# Resolution of the Task A-11 Reactor Vessel Materials Toughness Safety Issue

Part I - Main Report, Part II - Staff Responses to Public Comments,  
and Appendices A and B

**U.S. Nuclear Regulatory  
Commission**

Manuscript Completed: July 1982  
Date Published: October 1982

Figure 5.1 Schematic Curves of  $J=f(T)$  Illustrating the Material and Structural (Applied) Curves the Intersection Denoting Instability.

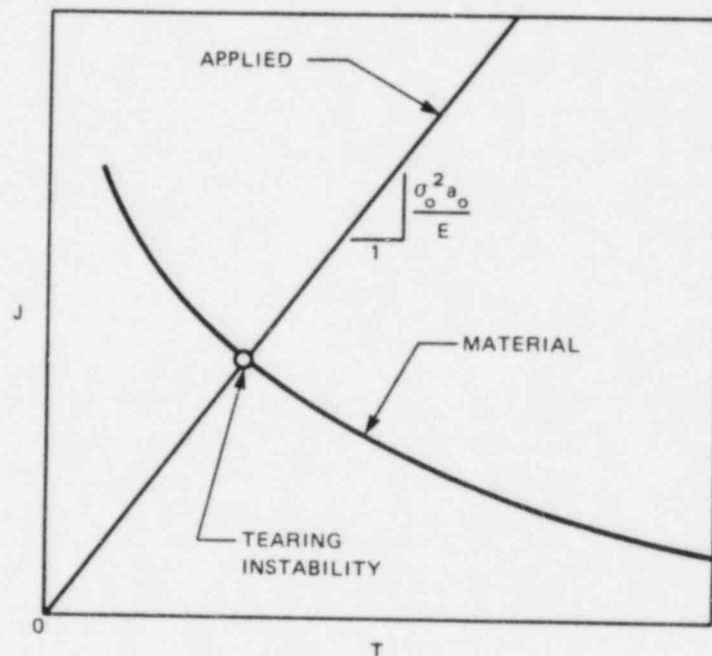
Comment 43: Pg 5-2: Figure 5.1 should show  $J_{IC}$ .  
(Specific)

Resolution: Showing  $J_{IC}$  on Figure 5.1 is not germane to the purpose, which is to illustrate, schematically, the way to determine crack instability (the onset of test fracture) under conditions that can be analyzed with applied elastic-plastic fracture mechanics. In fact, it would be a distraction. Also, the current methods for determining  $J_{IC}$  involve data reduction to obtain two straight lines--the blunting line and a linear representation of the J-R curve between the exclusion lines. The schematic material curve of Figure 5.1 would not accommodate the two straight lines and, at the same time, serve the author's purpose, which is to emphasize the nonlinearity of the J-R curves.

Figure 5.2 J-R Curves From a Low USE A-302B Steel Showing No Size Effect Between; 0.5T and 1T CT Specimens at 25°C.

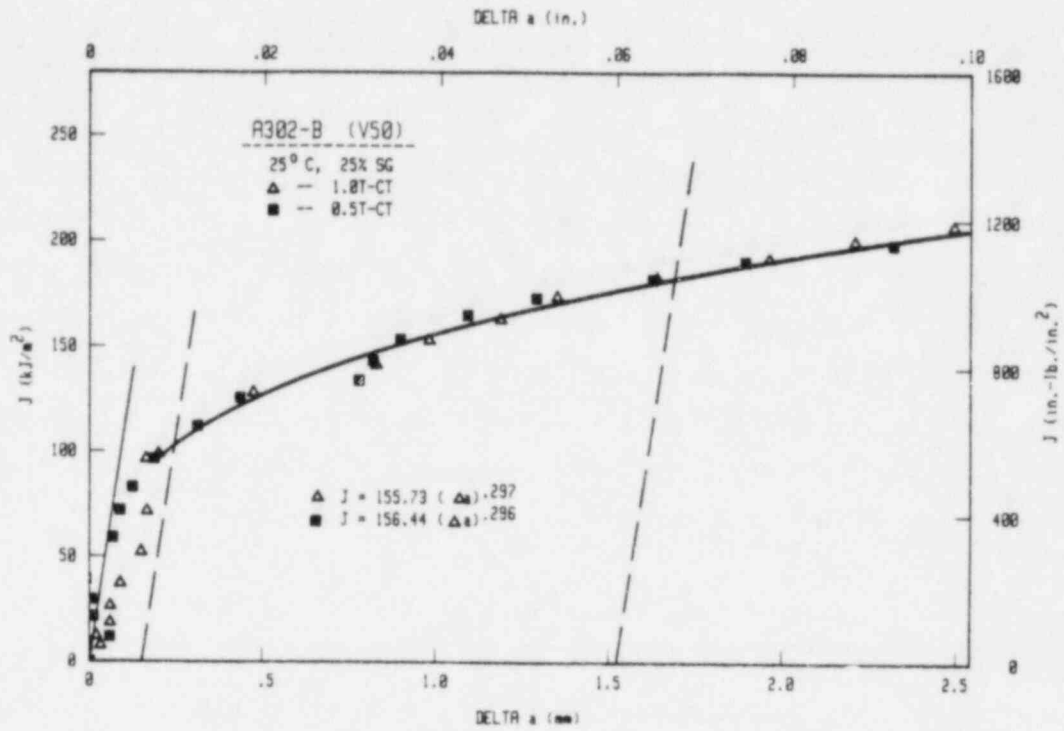
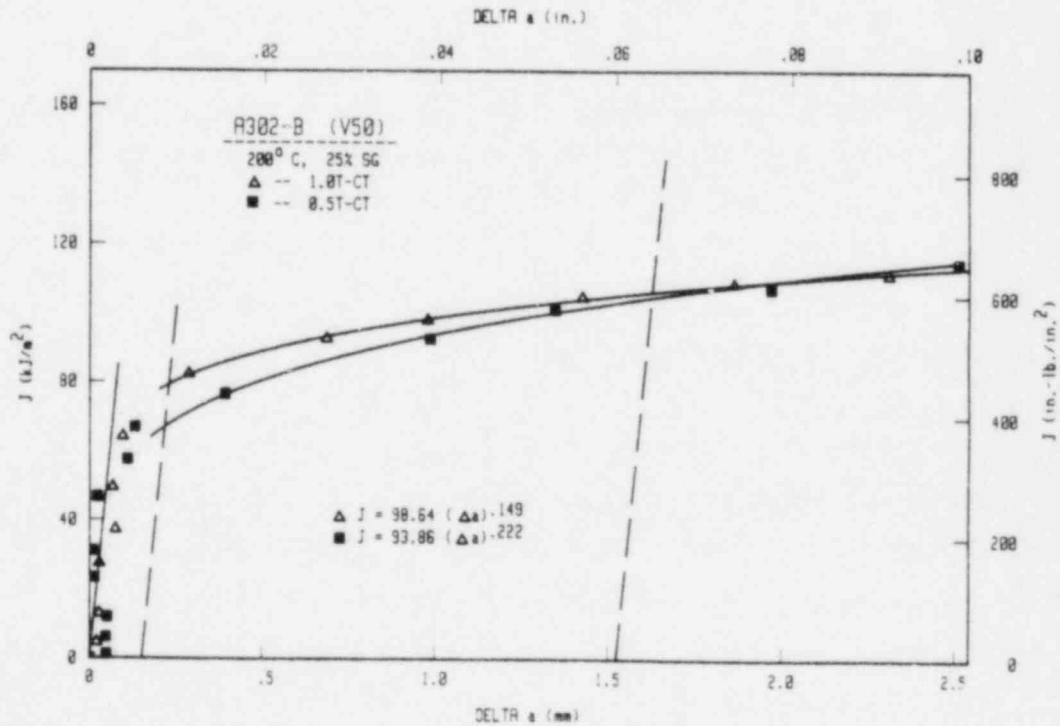
Comment 46: Figures 5.2 and 5.3: These should be credited as NRL data.  
(Specific)

Figure 5.8 HSST Intermediate Pressure Vessels Test Data

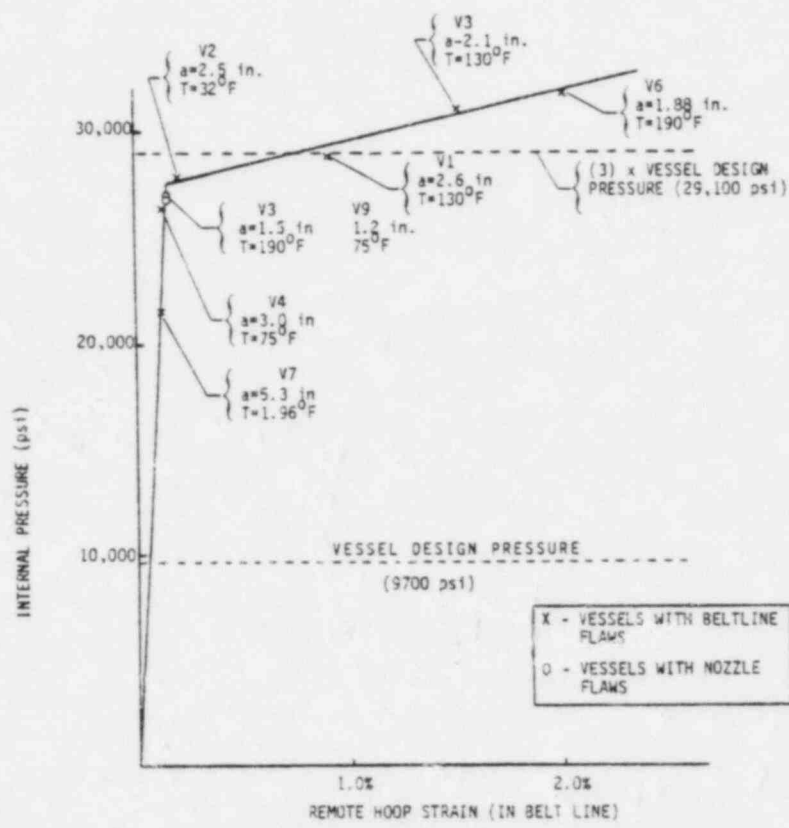
Comment 54: (Specific) What is the basis of the pressure-strain curve in Figure 5.8? How does one construct such a diagram for an actual pressure vessel?

Resolution: The P- $\epsilon$  curve of Figure 5.8 was based on measurements taken at failure of the ITVs noted. It is a reprint of Figure 2, Appendix H. The text accompanying that graph in Appendix H should be read. Because the curve was constructed using data from several vessel

Figure 5.9  $J_{mat}$  Vs.  $T_{mat}$  Curves of Figure 6, Appendix H

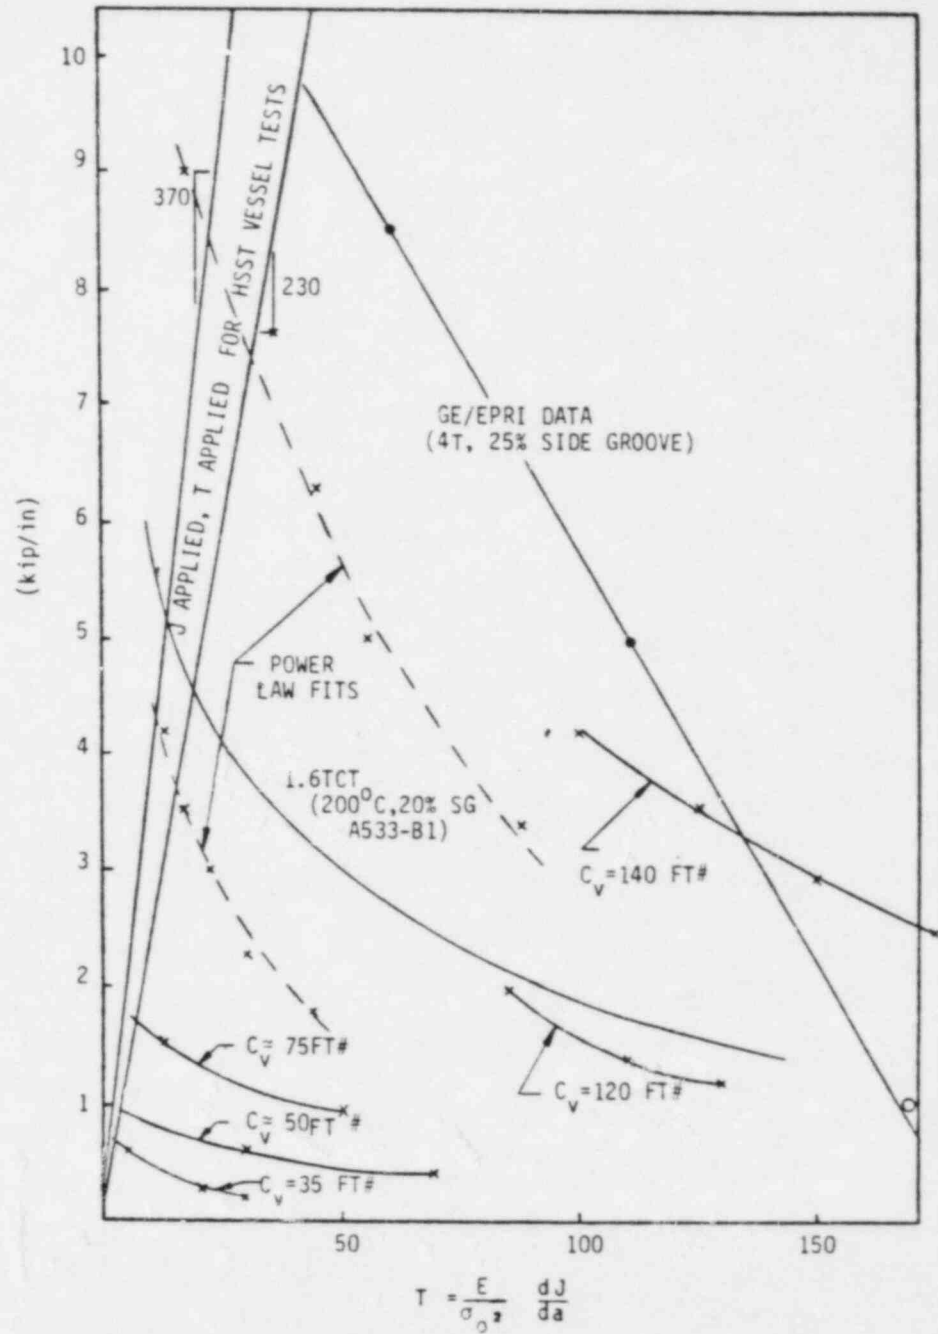
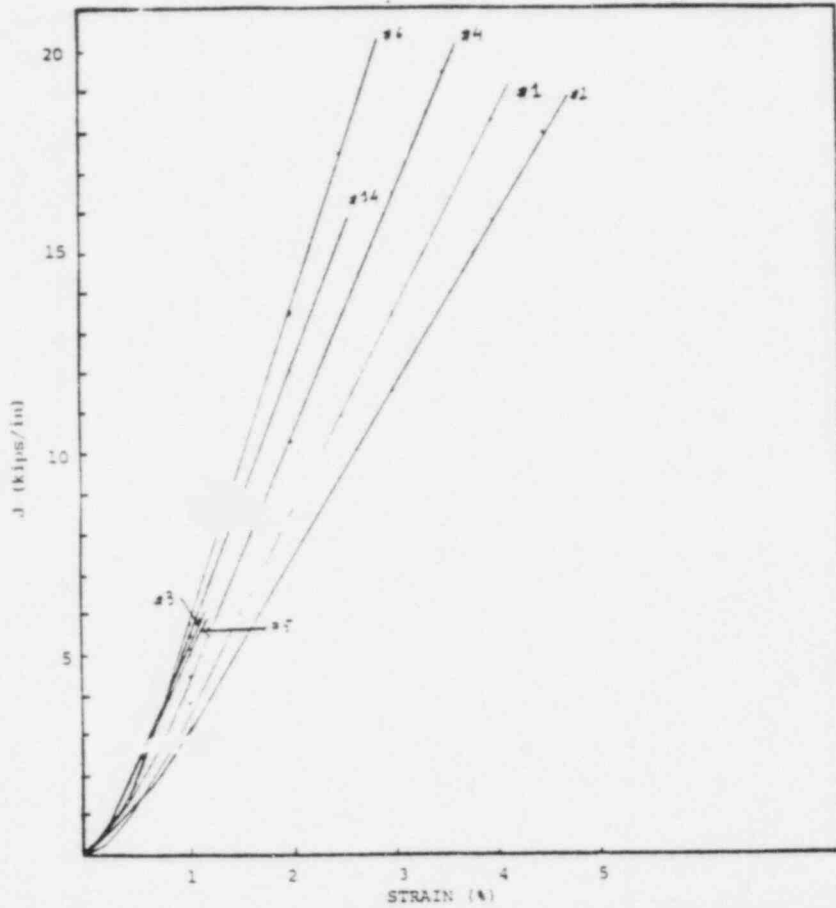
Comment 47: Figures 5.9 and 5.11: The upper line labeled "GE/EPRI Data" may be too high based on estimates by Loss and Berggren. It should be determined whether the GE experimental data contain a correction for crack extension. This correction will lower the J-R curve. In addition, the NRL data are for 200°C. It is known that the R curve falls with rising temperature. This fact is not mentioned in the comparison with vessel tests.  
(Specific)

Figure 5.12  $J$  Vs.  $T$  Curves for the Large Tensile Specimens Corrected for Plane Stress

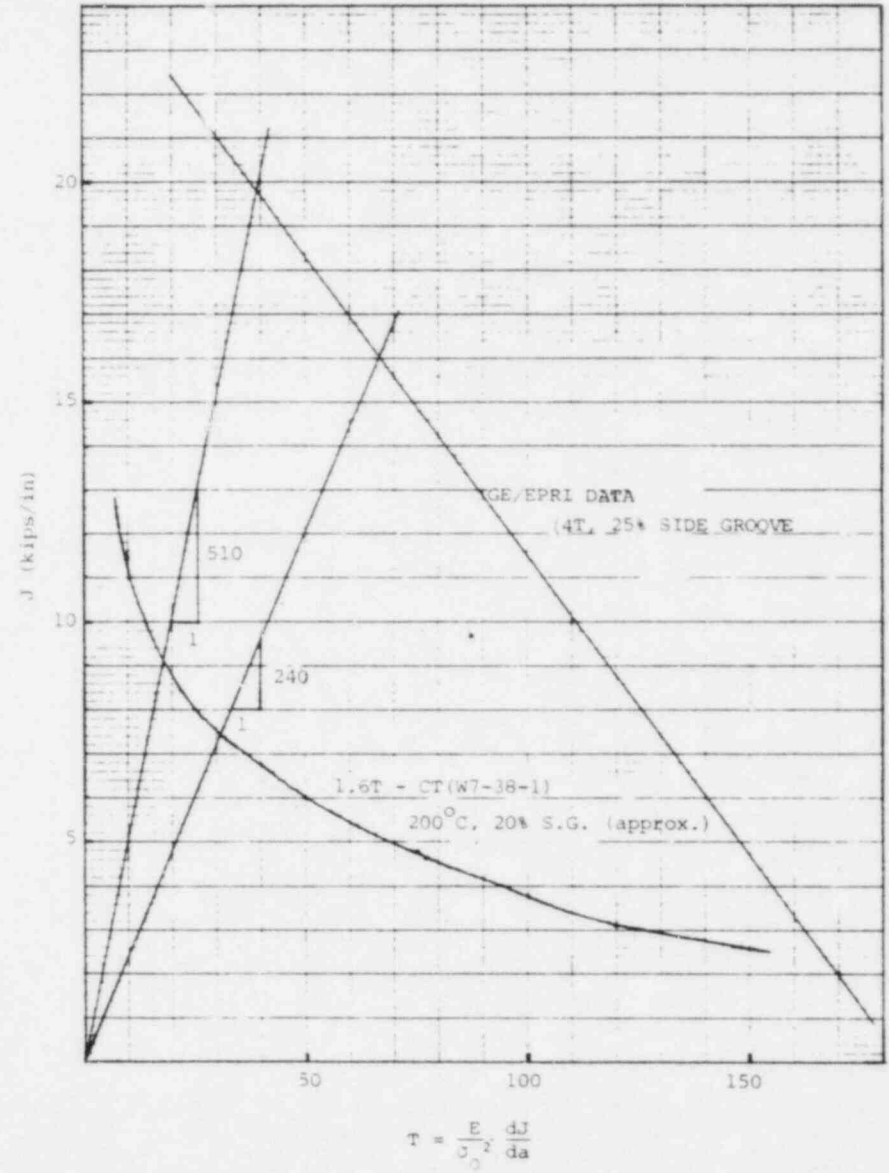
Comment 48: Pg 5-18: What is a "coupled J value"? Where is it shown on  
(Specific) Figure 5.12?

Figure 5.13 Correlation between  $J$  (at the intersection of the  $J/T = 50$  in.-lb/in.<sup>2</sup> load line and a materials curve) and the corresponding Charpy upper shelf energy value

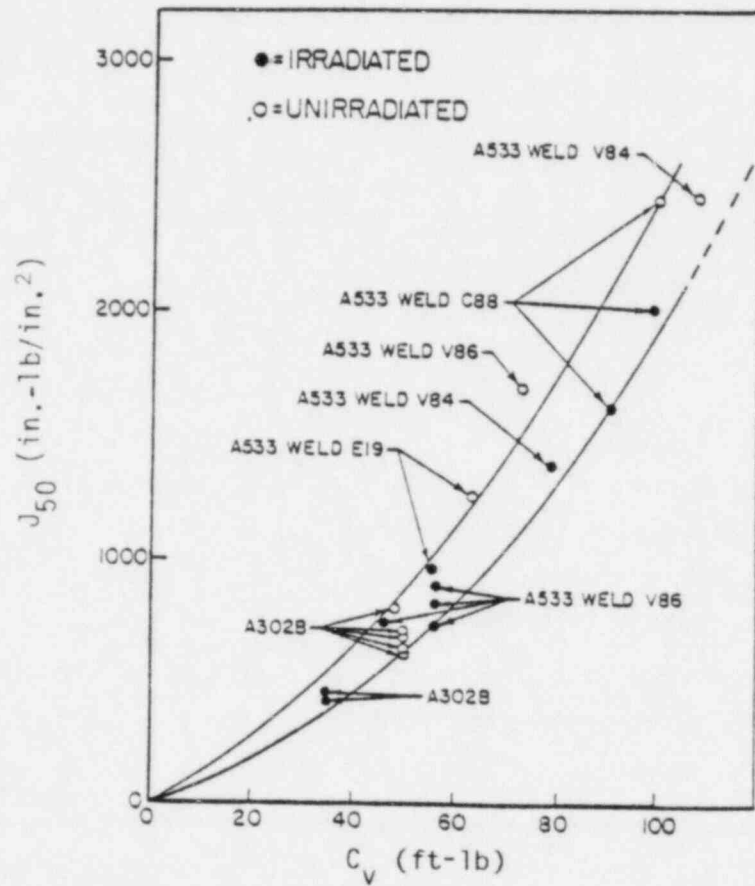
Comment 49: Pg 5-22, Figure 5.13: Is this the preferred figure or should  
(Specific) Figure 14 on pg D-23 be used? The latter was used in Appendix I. In the title to this figure, the words following "correlation" should be deleted.

Comment 50a: The units for J in Figure 5-13 are wrong. The implications of  
(Specific) this figure should be discussed in some depth, because it appears to be a key figure with regard to the proposed analysis.

Comment 50b: Pg 5.22, Figure 5.13: In the title to this figure, the words  
(Specific) "for Leak-Before-Break" should be deleted.

Resolution: The graph shown on pg 5-22 of NUREG-0744 is the one intended for Figure 5.13. It is not clear what was meant by the idea of "preferred" in the question. The lower bound correlation that is preferred as a part of an RPV analysis at any point in time will be that which is based on the most extensive collection of accurate, relevant data. The sentence on pg 5-22 that precedes Figure 5.13 addressed that point. The figure title has been changed.

Resolution: The problem with the units is a typographical error. It is believed that there is enough discussion of the implications of Figure 5.13, when all the discussions in the appendices are considered.

Figure 14 An attempted correlation of  $J_{50}$  values with Charpy upper shelf values from data by Loss

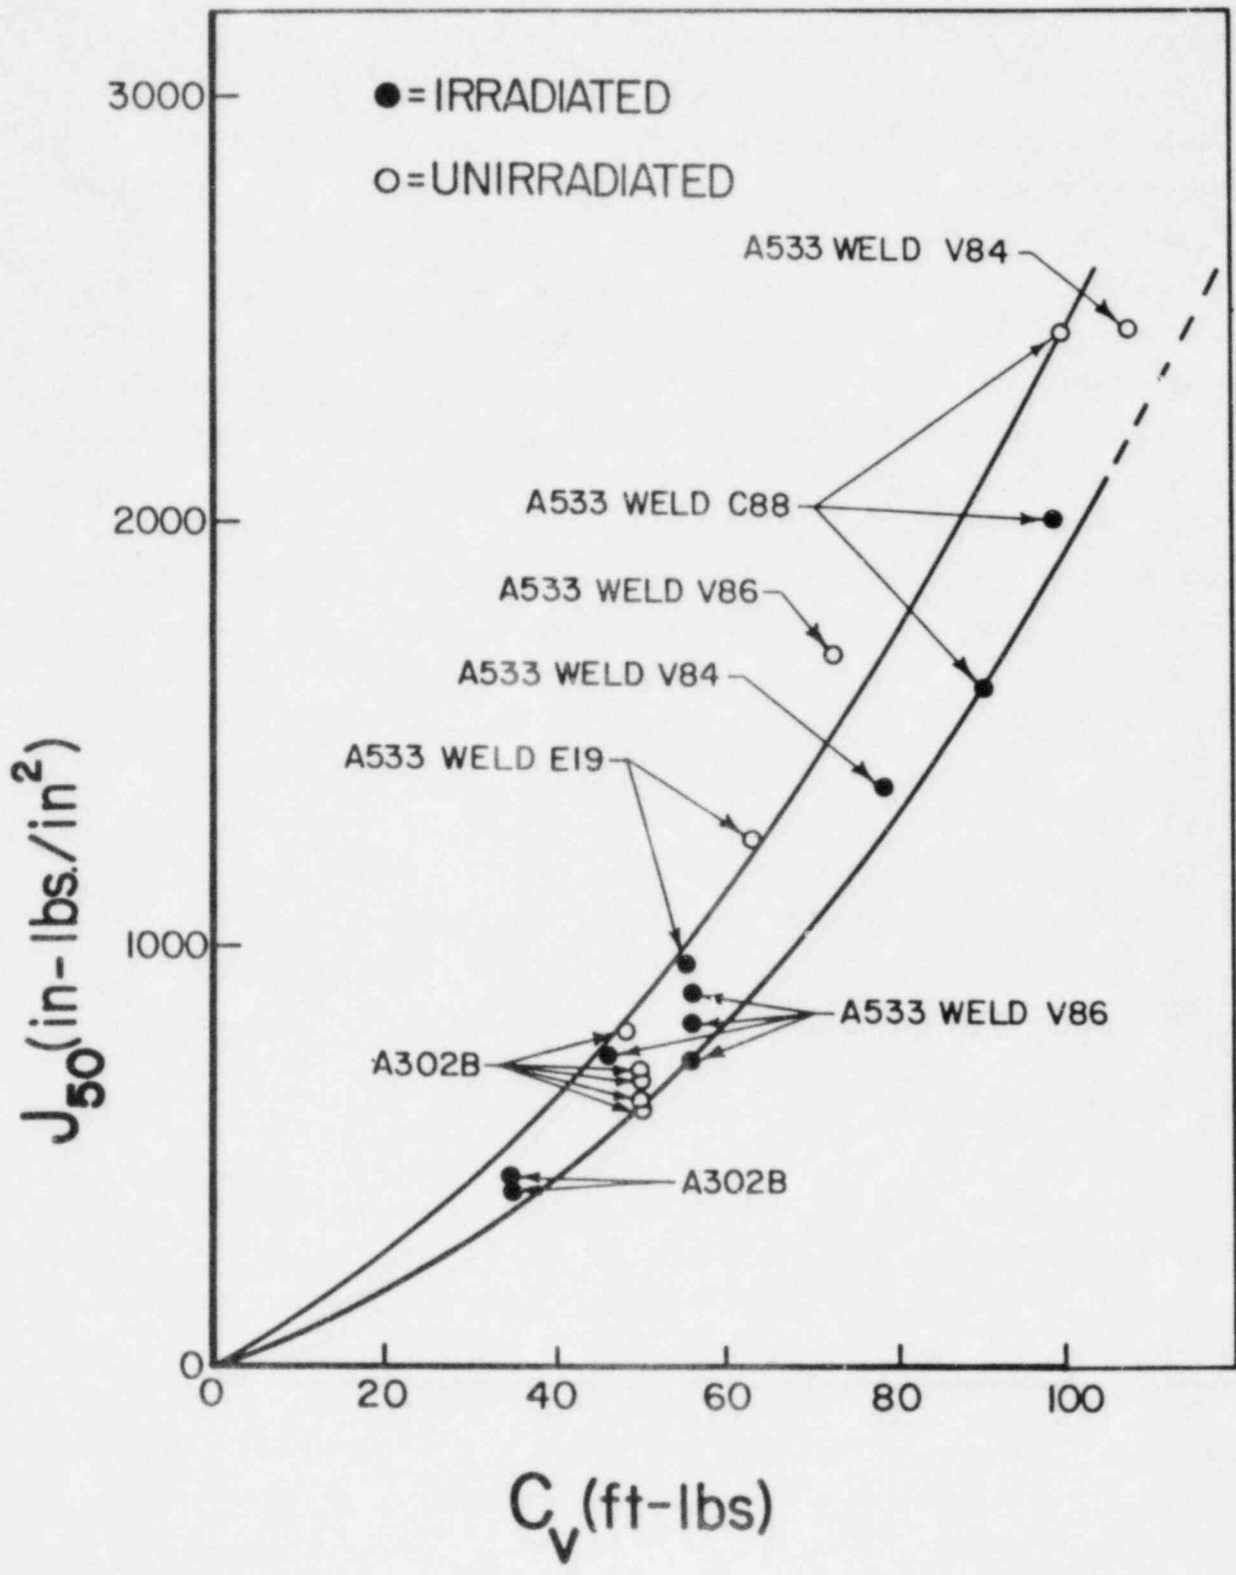
- o Absent plant-unique property curves, "the lower bound J (at  $J/T = 50$ ) =  $f(\text{USE})$  curve" is to be used. Which of the two different curves in the NUREG is preferred (Figure 5.13 or Figure 14 on pg D-23)?
